INSTRUCTION TO SERVICE

ITS: 61283		March 4, 2025
SECTION:	219-Exhaust System	
WRITTEN BY:	New Flyer Service Engineering	
SUBJECT:	Replace existing turbo outlet exhaust elbow with redesigned elbow and gasket	
ISSUE:	Exhaust leak present at the turbo outlet and exhaust elbow joint	
SUMMARY:	The existing elbows will be replaced with a redesigned elbow that has a gasket implemented in the joint to ensure no exhaust leak is present.

Figure 1: Align Turbo Exhaust Elbow and Torque Clamps

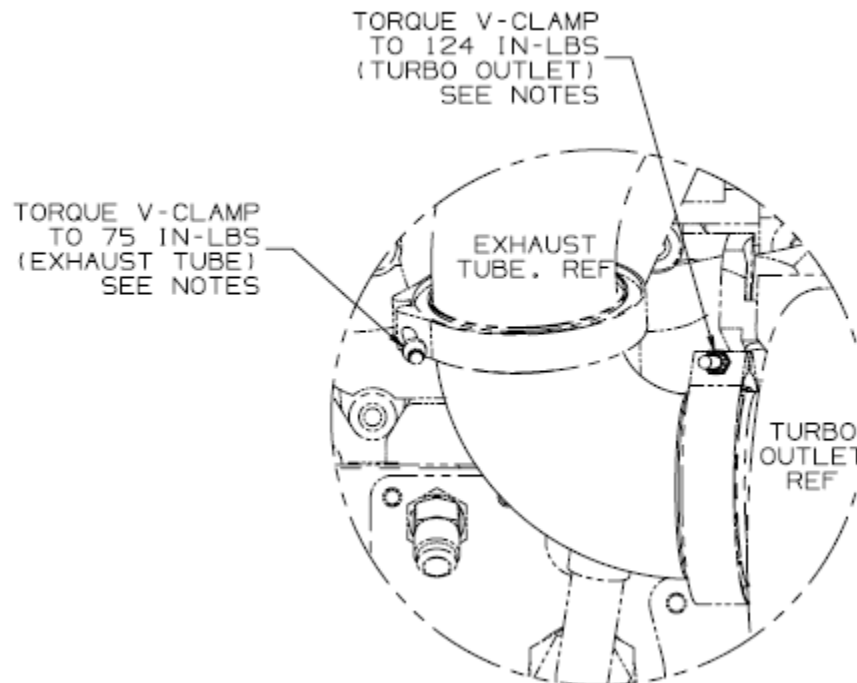
1. Set park brake and chock wheels.
2. Turn the main battery disconnect switch to the “OFF” position.
3. In the engine compartment of the bus, locate and remove and retain the existing turbo outlet exhaust elbow and clamps.
4. Inspect the existing gasket on the exhaust tube side of the elbow for gasket integrity. If any damage is found replace with a new gasket (NF PN 395859).
5. Insert the new gasket into the turbo outlet end of the exhaust elbow and install the redesigned exhaust elbow (NF PN 1115025).
6. Ensure the turbo exhaust elbow is aligned with both the turbo outlet and the exhaust tube. Torque the existing clamps as shown in Figure 1.

7. Tap lightly around the perimeter of the clamps with a rubber mallet to ensure the elbow and gaskets have properly seated, then recheck the torque on the clamps. Repeat as required until the torque value is consistently maintained.
8. Return the removed turbo exhaust elbow to your New Flyer Regional Product Support Manager.
9. Clean up all tools and debris and return the bus to service condition.
10. Turn the main battery disconnect switch to the “ON” position.
